COOPER NUCLEAR STATION

PROPOSED AMENDMENT TO FACILITY OPERATING LICENSE

CHANGE NO. TO THE TECHNICAL SPECIFICATIONS

SAFETY EVALUATION BY THE DIRECTORATE OF LICENSING

**FIGURE 3.5.1 MAXIMUM ALLOWABLE
AVERAGE PLANAR LHGR**

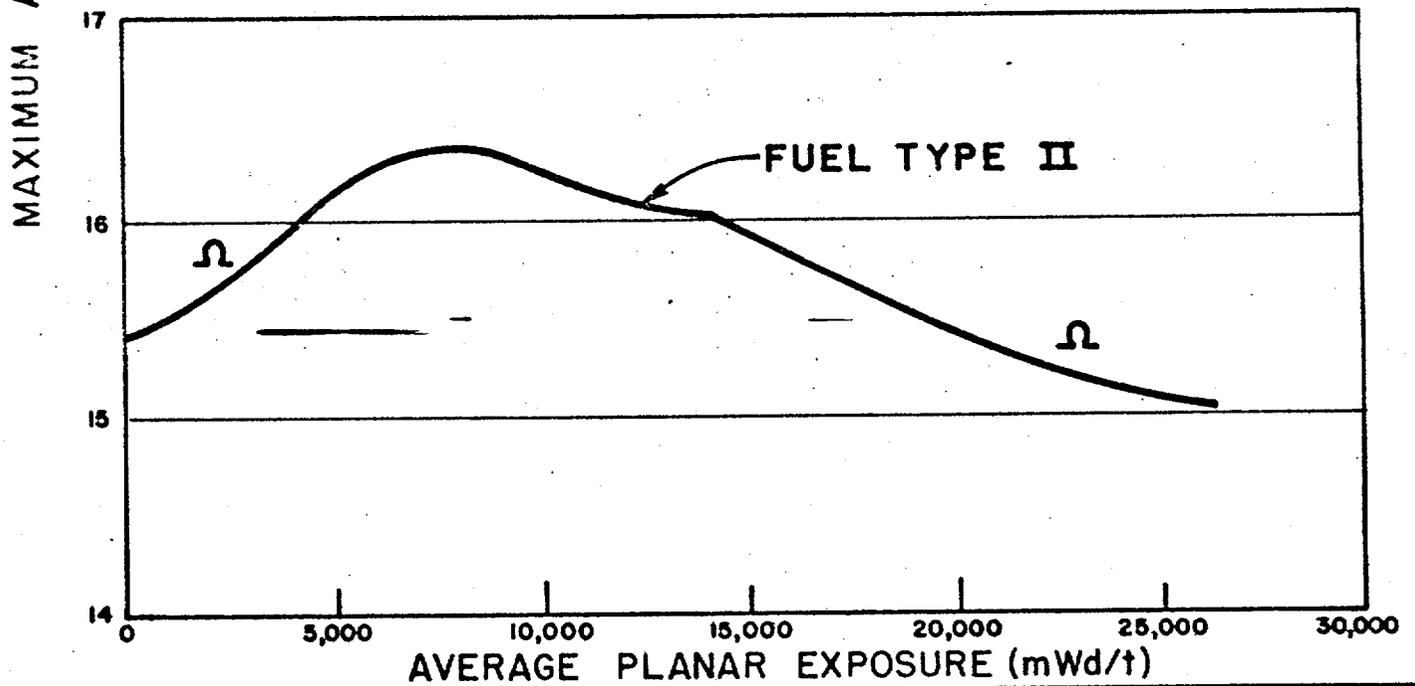
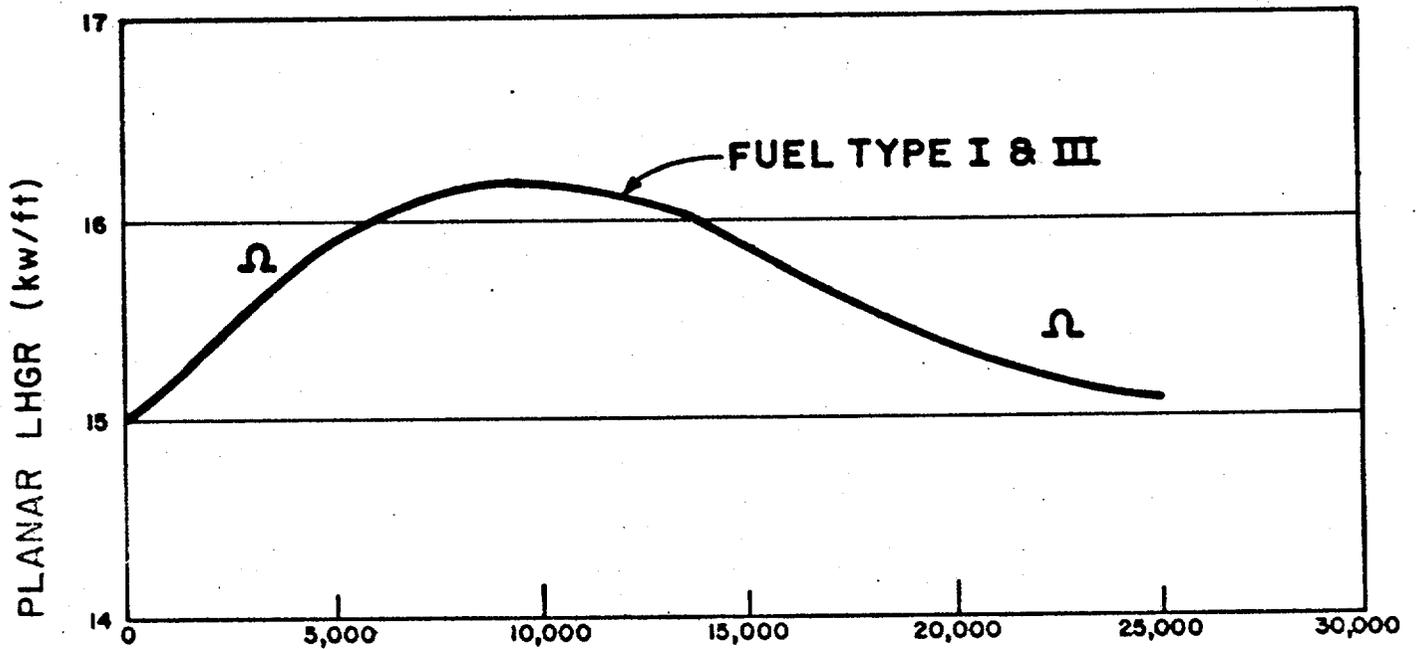
The maximum average planar LHGR's shown in Figure 3.5.1 are based on calculations employing the models described in the General Electric Report NEDM-10735 as modified by General Electric Report NEDO-20181, which was modified by the Regulatory staff in "Supplement to the Technical Report on Densification of General Electric Reactor Fuels, December 14, 1973".

In a letter dated May 28, 1974, the Nebraska Public Power District (NPPD) transmitted a series of proposed changes to the Technical Specifications, Appendix A, of Facility Operating License No. DPR-46 for the Cooper Nuclear Station (CNS). The proposed change addressed in this safety evaluation would increase the maximum average planar linear heat generation rate (MAPLHGR) specified in Section 3.5.I of the Technical Specifications.

The proposed Technical Specifications submitted by NPPD are the result of applying the accepted GE model for fuel densification to the CMS. The GEGAP III model yields a calculated increase in pellet-clad conductance primarily due to fuel relocation and associated gap closure. An increase in gap conductance causes a decrease in stored energy in the fuel rods which, for a given MAPLHGR value, reduces the calculated peak clad temperature following a postulated LOCA, or, conversely, allows a compensating increase in MAPLHGR for a constant calculated peak clad temperature. The limit curves for MAPLHGR specified in the proposed change represent limiting values on LHGR and peak clad temperature following a LOCA. The staff concludes that the limitations on the MAPLHGR given in Figure 3.5.1 combined with the local LHGR limitations given in Specification 3.5.J of the Technical Specifications will assure that even after accounting for postulated effects of fuel densification the calculated peak clad temperature for the design basis LOCA will not exceed 2300°F and the design limits on LHGR and MCHFR will be maintained during normal and transient operations.

Along with the revised MAPLEGR specifications, the staff has incorporated appropriate Bases into the Technical Specifications. This change is implemented by replacing pages 129, 130 and 131a.
